TfNSW Reference: SYD21/00556/07

**ADDITIONAL INFORMATION FOR GENESIS HEALTH SERVICES FACILITY - LOT 1
DP 883417 CAMDEN, KELLICAR, NARELLAN ROADS, CAMPBELLTOWN**

TfNSW raises the following design and traffic modelling matters that the applicant needs to address for the concept traffic control signal and civil design:

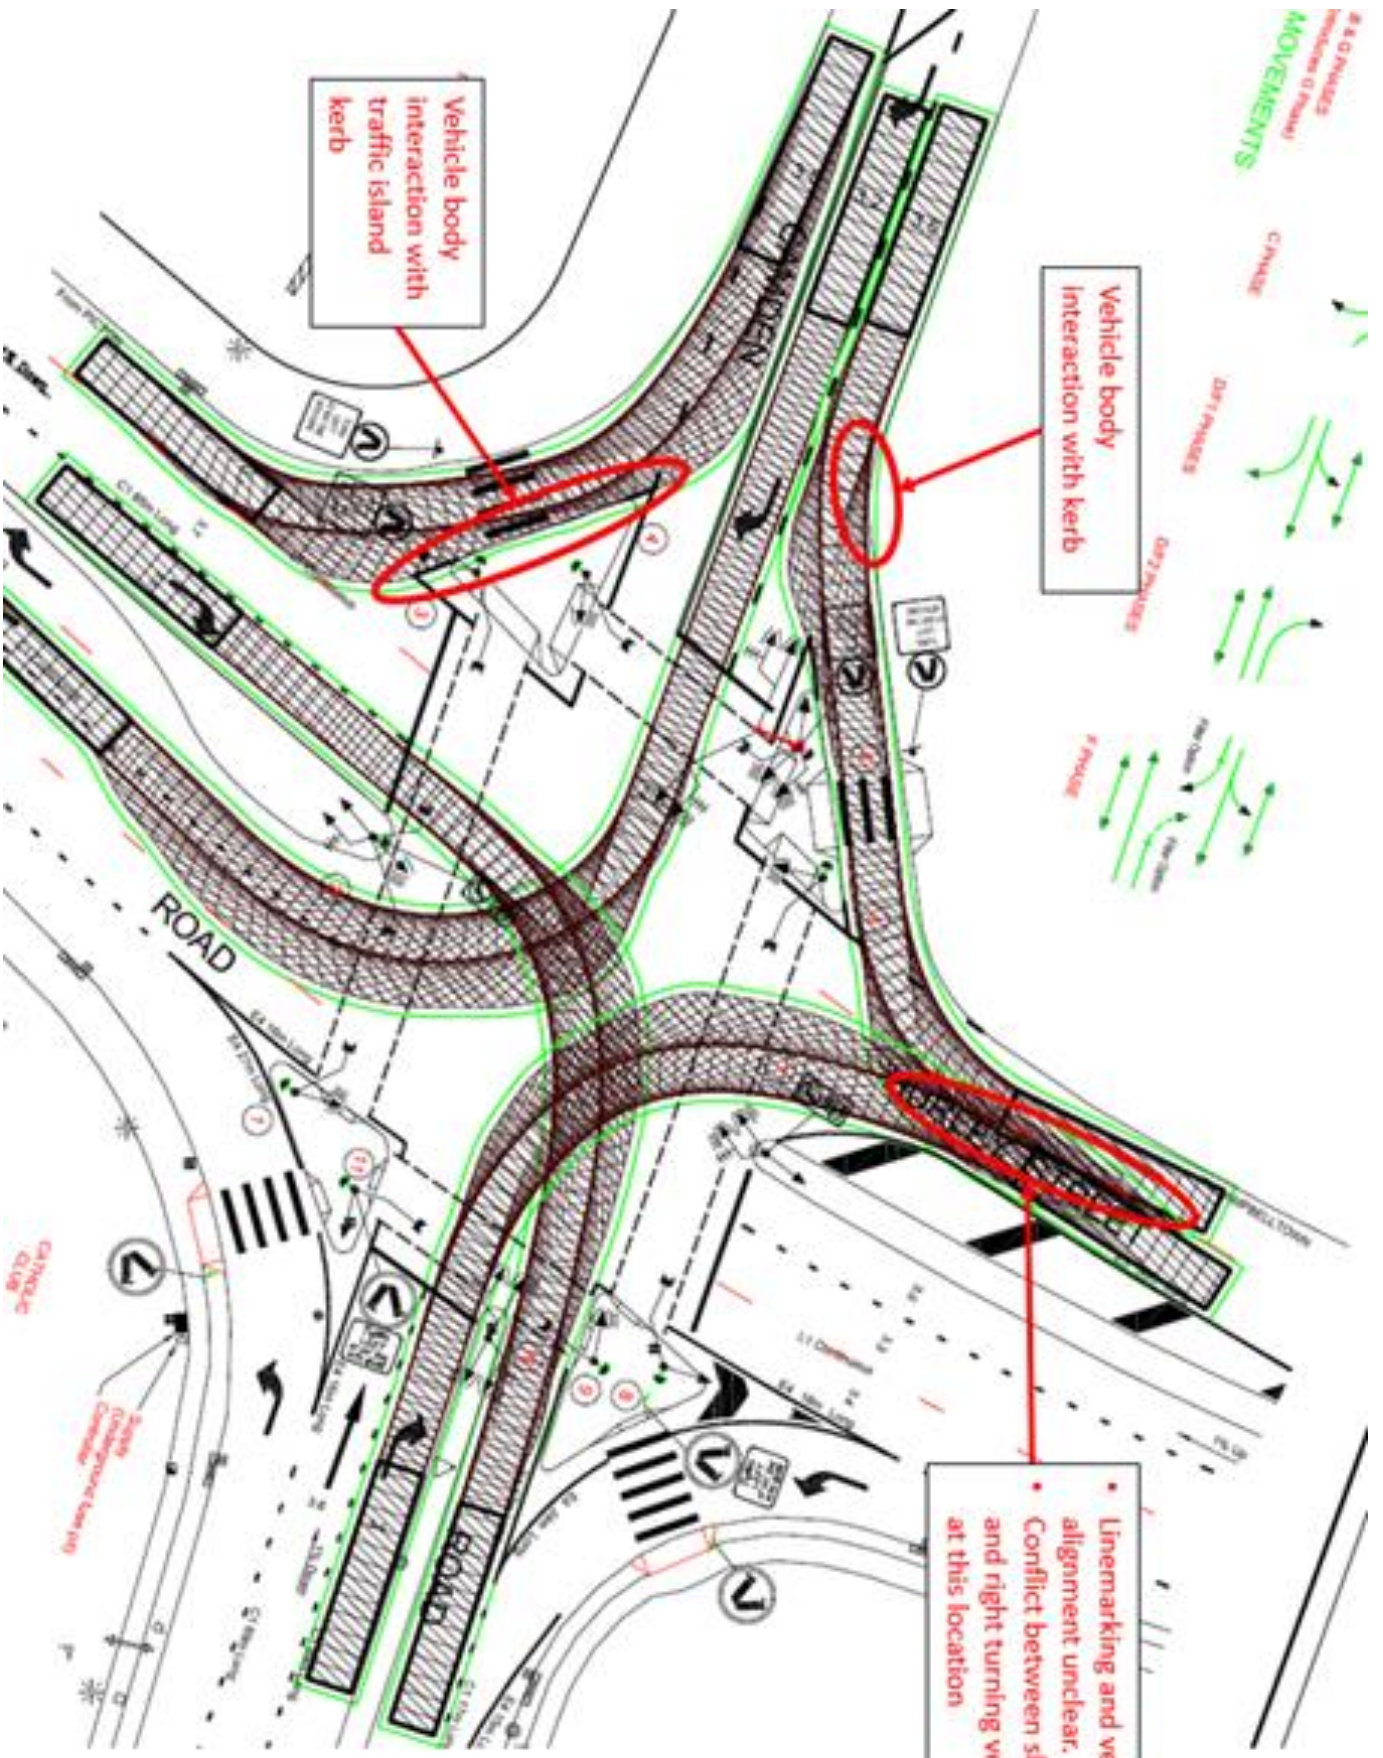
5. A minimum offset of 0.5m should be provided to the island edge.
6. Mast arms for proposed traffic signals require 2m offset.
7. Swept path movements should be provided on separate swept path plans to improve legibility of line marking and vehicle alignments. Please see the attached image for your reference.

8. Swept path movements for left turning vehicles from Camden Road onto Hurley Street indicate inadequate clearances as vehicles encroach onto the kerb to perform this movement. Please see the attached image for your reference.

9. Swept path movements for left turning vehicles from Camden Road onto Hurley Street indicate conflict with right turning vehicles from Camden Road. Please see the attached image for your reference.

10. Swept path movements for left turning vehicles from Kellicar Road onto Camden Road indicate inadequate clearances as vehicles encroach onto the traffic island kerb to perform this movement. Please see the attached image for your reference.

Vehicle body
interaction with kerb

Vehicle body
interaction with
traffic island
kerb

- Linemarking and vehicle alignment unclear.
- Conflict between slip lane and right turning vehicles at this location
